SP2022-035

PROJECT NUMBER: SP2022-035  
PROJECT NAME: Site Plan for Harbor Residences  
SITE ADDRESS/LOCATIONS:

CASE CAPTION: Discuss and consider a request by Asher Hamilton of RIV Properties, LLC for the approval of a Site Plan for a 176-unit condominium building on a 3.59-acre tract of land identified as Lots 1, 2, 3, & 4, Block 2; Lots 1, 2, 3, & 4, Block 3; Lots 1, 2, 3, & 4, Block 5; Lots 1 & 2 and a portion of Lots 3 & 4, Block 6; Lots 2, 3, & 4, Block 7; Lots 1 & 2, Block 8; and Lots 1, 2, 3, & 4, Block 9, Moton Addition, City of Rockwall, Rockwall County, Texas, situated within the Hillside Mixed Use Subdistrict and the Horizon/Summer Lee Subdistrict of Planned Development District 32 (PD-32), generally located at the southwest corner of the intersection of Horizon Road and Summer Lee Drive, and take any action necessary.

DEPARTMENT	REVIEWER	DATE OF REVIEW	STATUS OF PROJECT
PLANNING	Henry Lee	06/24/2022	Needs Review

SHEET NUMBER AND TITLE:  
4.1 TREESCAPE PLAN

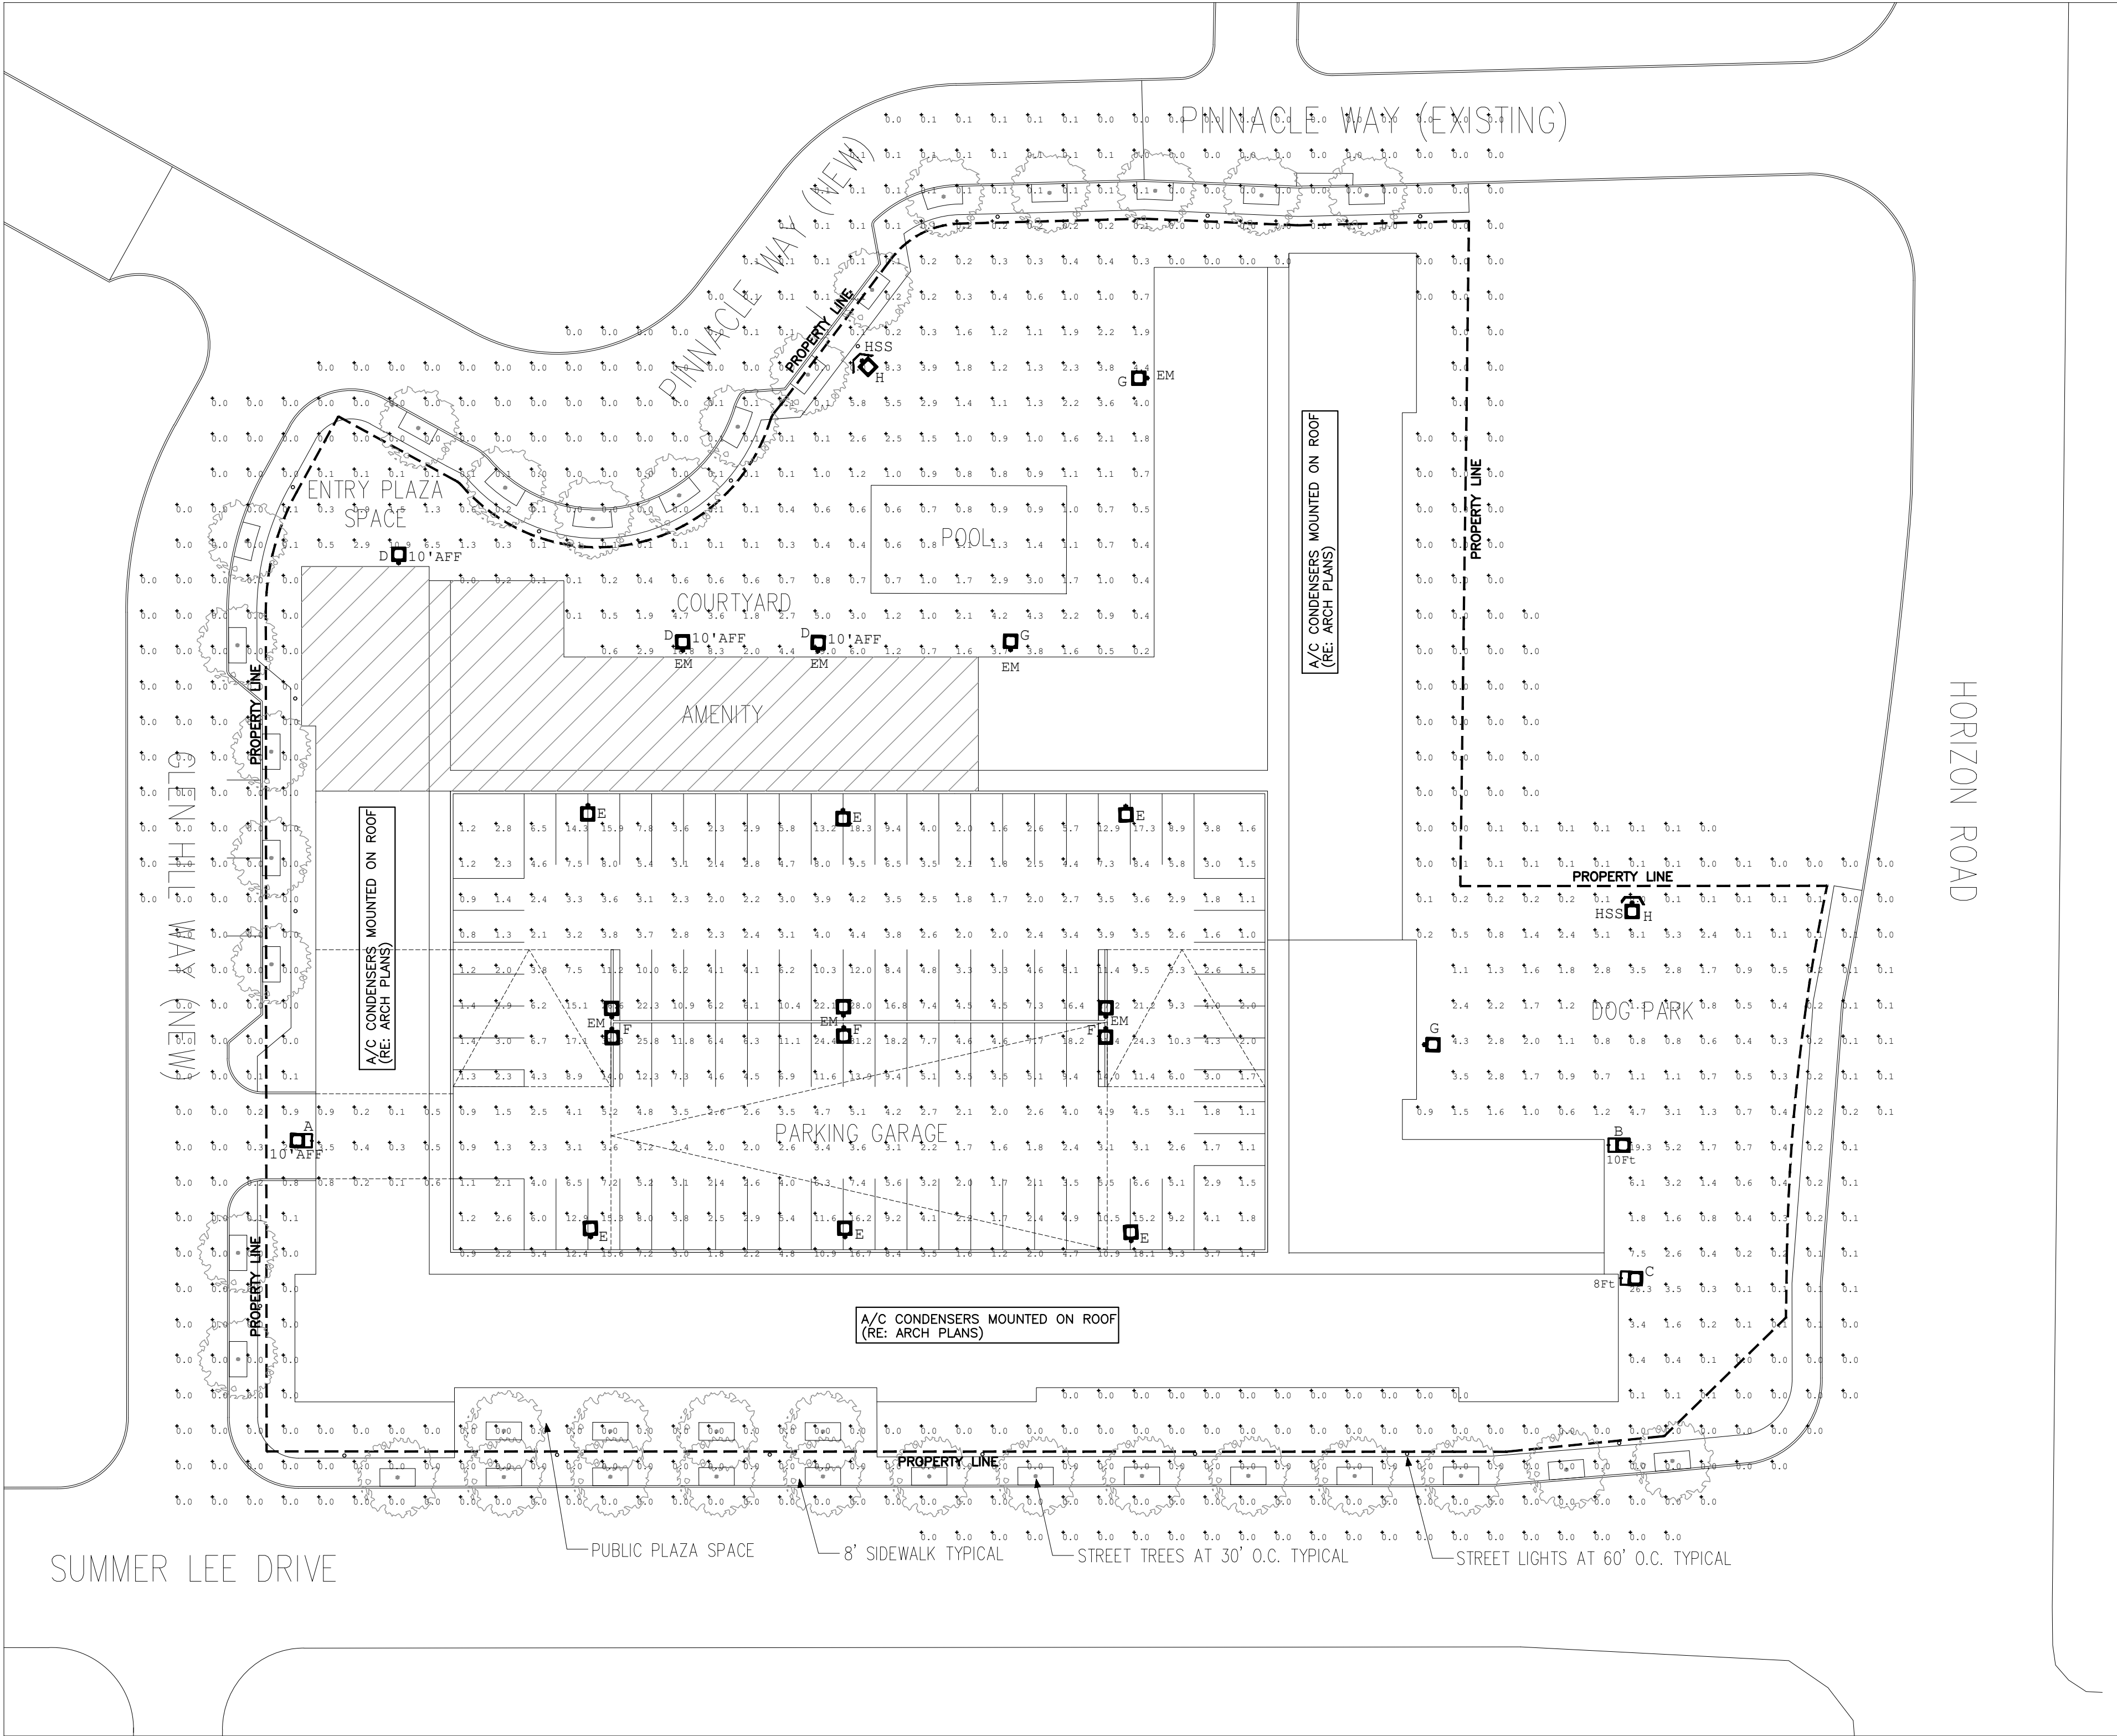
M.11 Treescape Plan:

1. Provide the same site data as the site plan site data table. (See Sec. 2.1 of this checklist)
2. The total mitigation is 801.5 caliper inches. Based on the current landscape plan you are replanting 208 caliper inches, which leaves a mitigation balance of 593.5. This does not meet our 80/20 replanting vs. payment ratio. You will need to request an Alternative Tree Mitigation Settlement Agreement in conjunction with this case. The agreement requires approval from both the Planning and Zoning Commission and City Council. I will just need a letter requesting the agreement, which outlines the total mitigation balance, the remaining mitigation balance, and why you are requesting the agreement. Payment for the remaining inches will be \$100.00 per inch.
